City of Plymouth Planning Commission

Regular Meeting Agenda

Wednesday, December 8, 2021 – 7:00 p.m.
ONLINE Zoom Webinar

**Special Land Use and
Site Plan Review
For
Plymouth, Michigan**

PROPOSED SITE PLAN

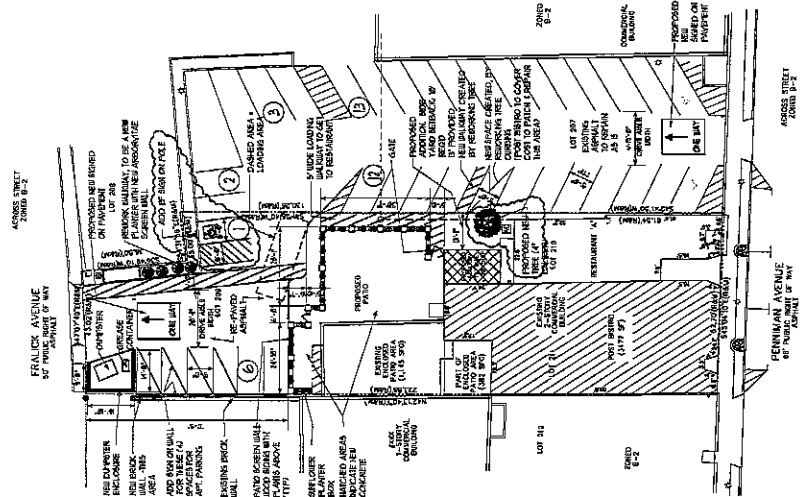
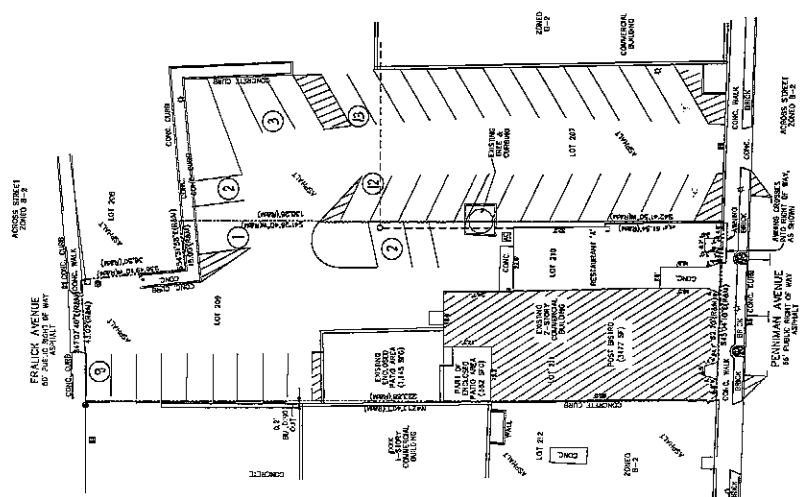
Revise plans to show an 8-foot-wide barrier-free parking space aisle -Shown on revised plan from architect Scott Monchnik.

Plans to show replacement tree is at least 4" caliper in size. 2" caliper tree will be a 4" caliper tree-shown on revised plan from architect Scott Monchnik.

Applicant to obtain permission from Westborn Market to extend the brick wall, as shown on the Site Plan. Wall to match Westborn wall. Dumpster enclosure to match Westborn wall and be big enough to house dumpster and grease trap. Attached letter shows Westborn's endorsement of project and submitted plans.

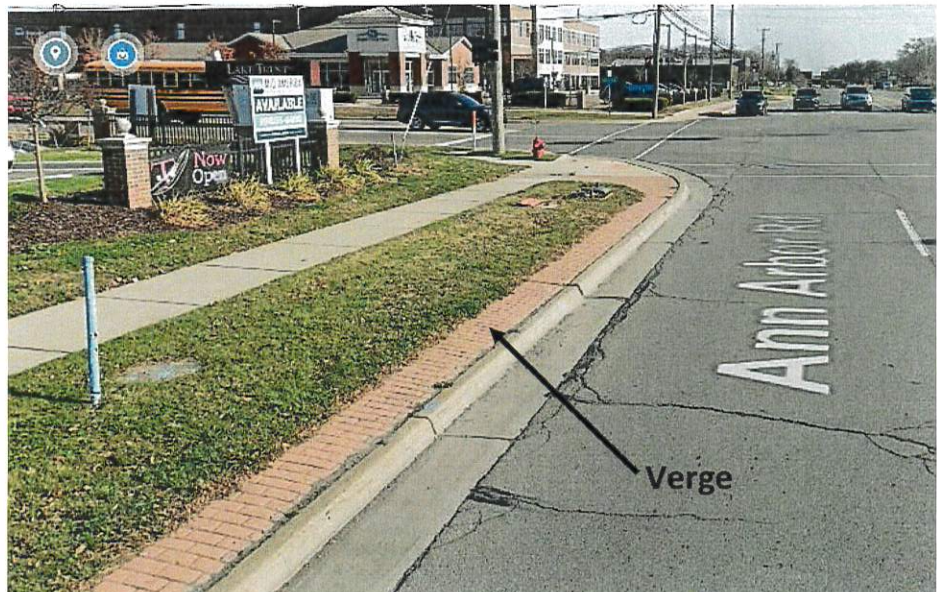
- Sheet L2.01. Section 78-171 ("Ann Arbor Road Standard Design Details"). The designer has created their own detail for the aluminum fence/masonry pier to add structural details. However, some manufacturer information is missing that is on the standard detail. The details on the plans should include all information on the standard details. Also, a note should be added that states: "The streetscape elements shall be consistent with the standards and requirements of the Ann Arbor Road Streetscape Prototype, "Ann Arbor Road Standard Design Details," dated October 16, 2003, illustrated in Section 78-171 of the City of Plymouth Zoning Ordinance." *The details have been modified to incorporate all of the*

information. Note a typo on Detail #6: U-Channel Railing should be 0.100 thickness, and not 0.0100.

01 SITE PHOTOMETRIC PLAN
SCALE: 1" = 10'

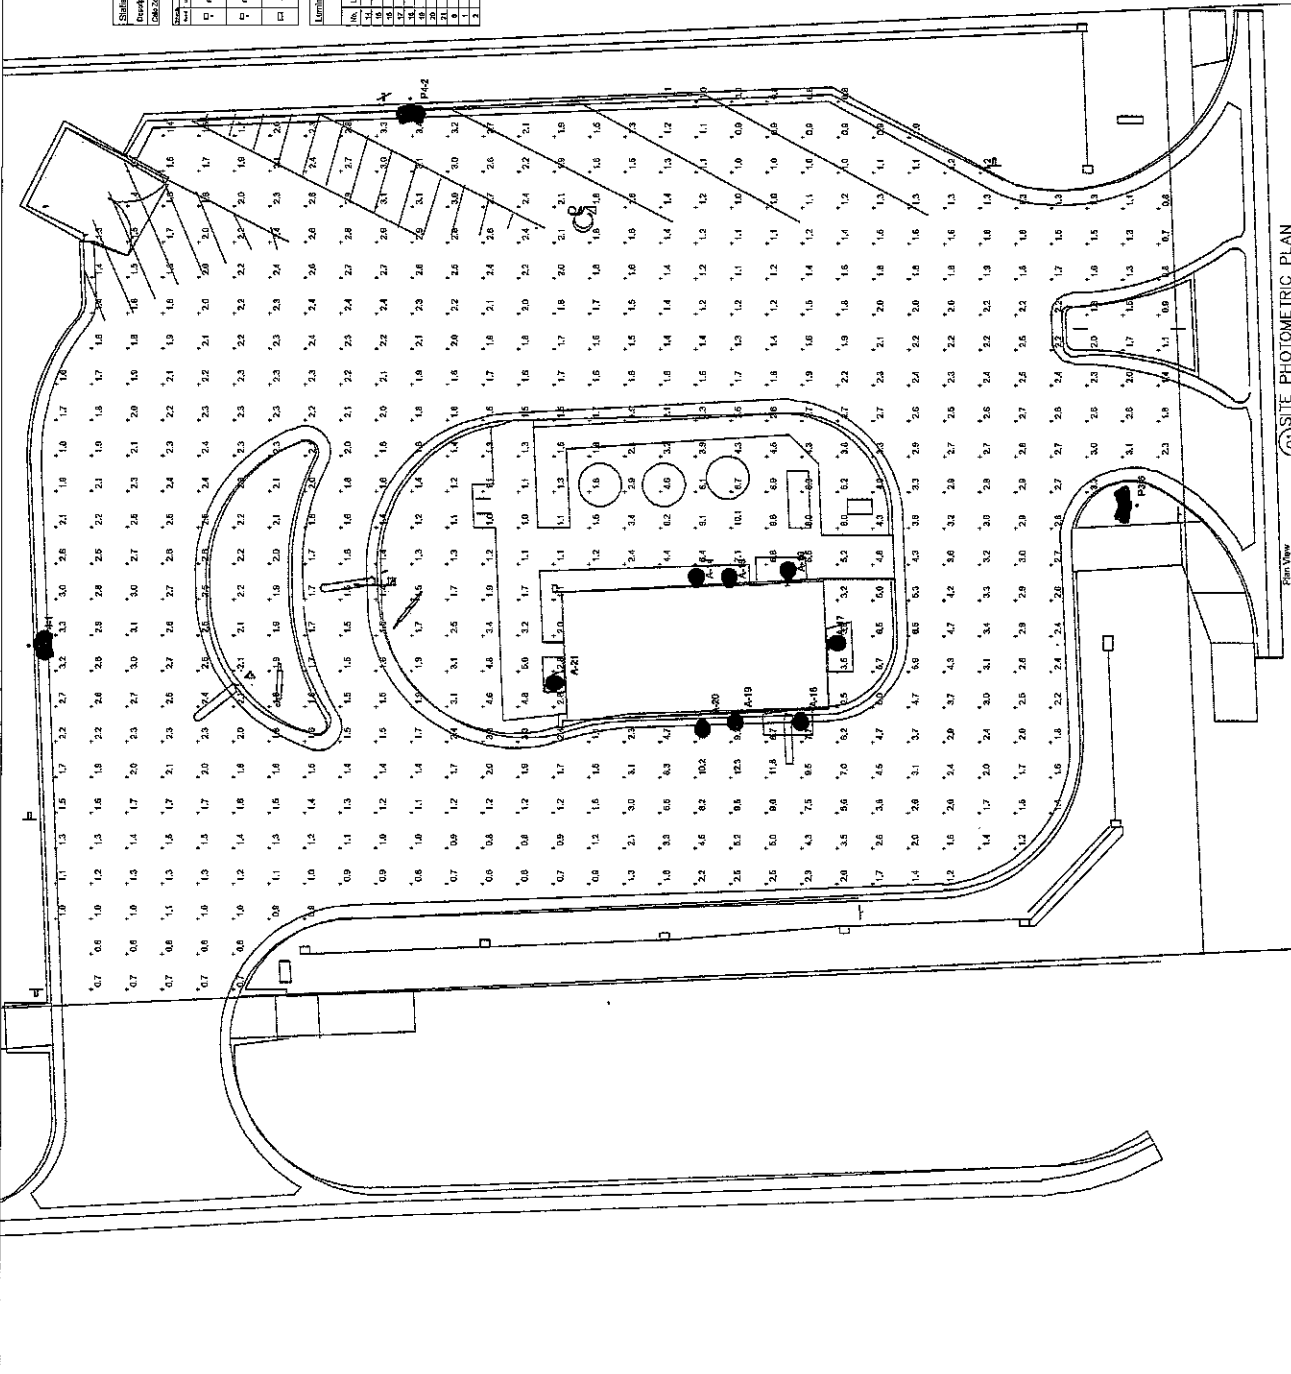
A lighting photometric plan has been submitted. This plan provides information about the light intensity and fixture height, but it does not provide information about the proposed fixtures themselves. Information showing that the proposed fixture meets the following standards needs to be provided:
